# GEH Presentation on Vallecitos Nuclear Center License Renewal Application

February 8, 2011

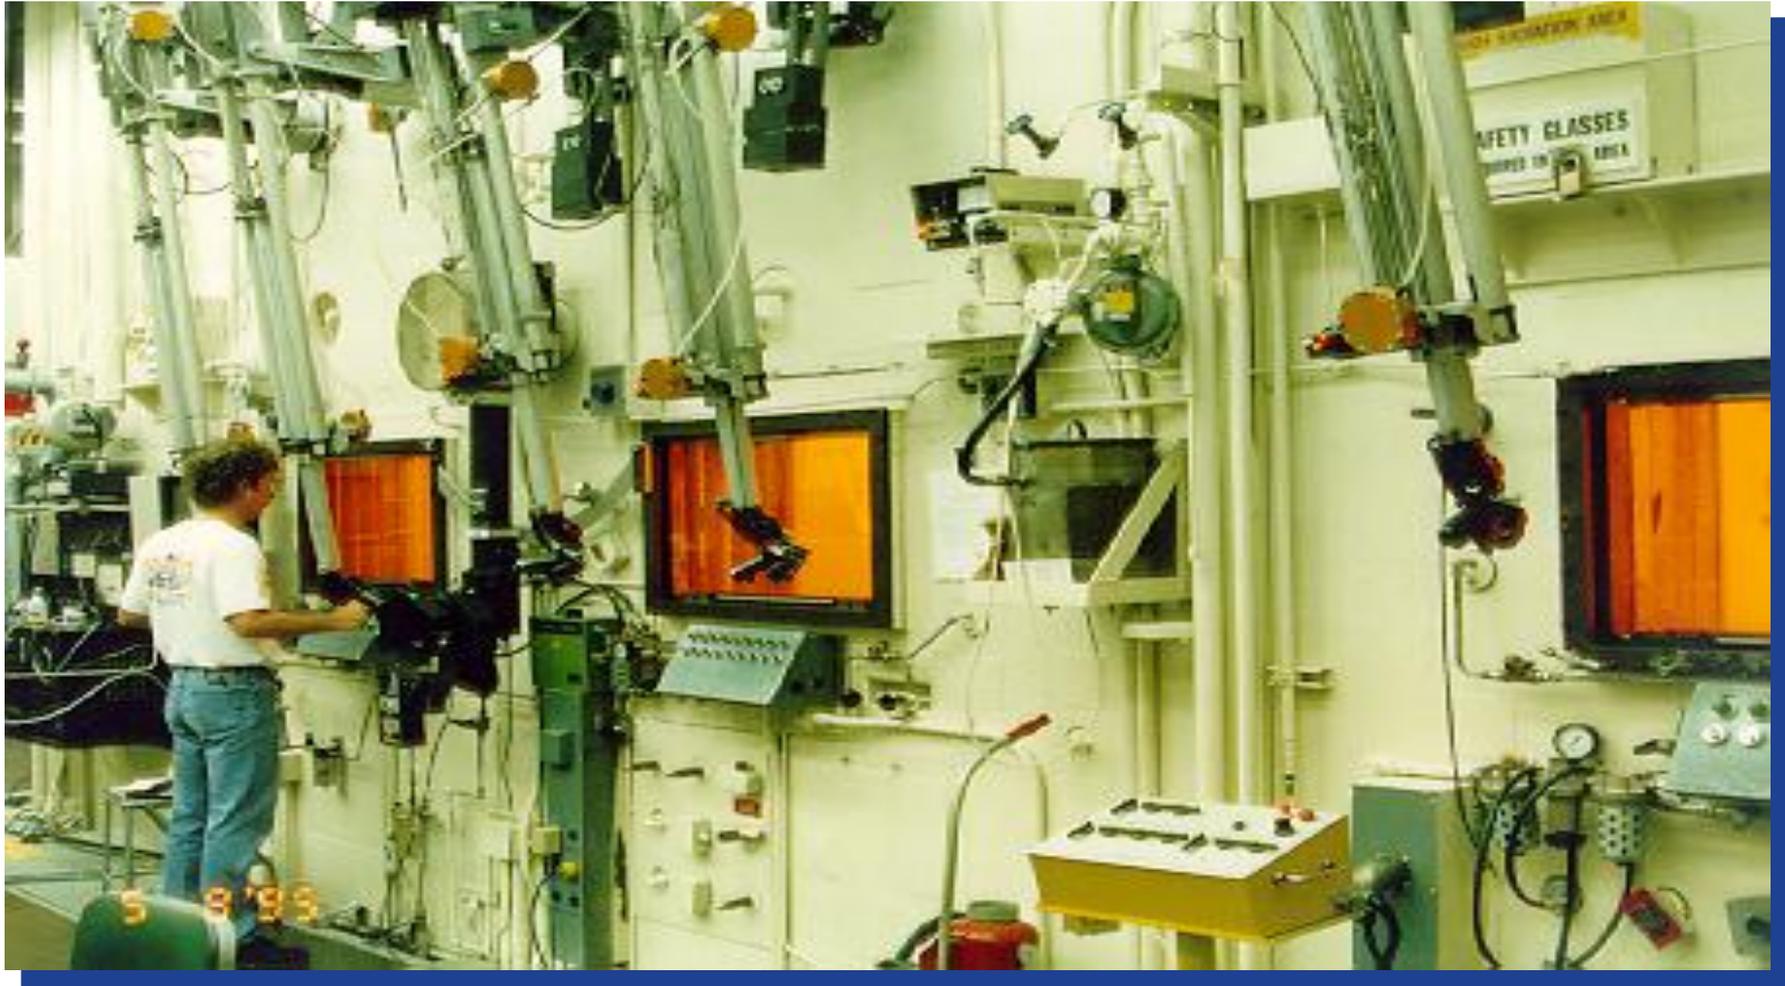
- Figures are often defined as “typical” - send pictures

- Figures are to be revised to remove clutter and highlight those features used to meet 70.22(a)(7)
- Photographs will be included to highlight some of the key items of interest
- Example photos follow
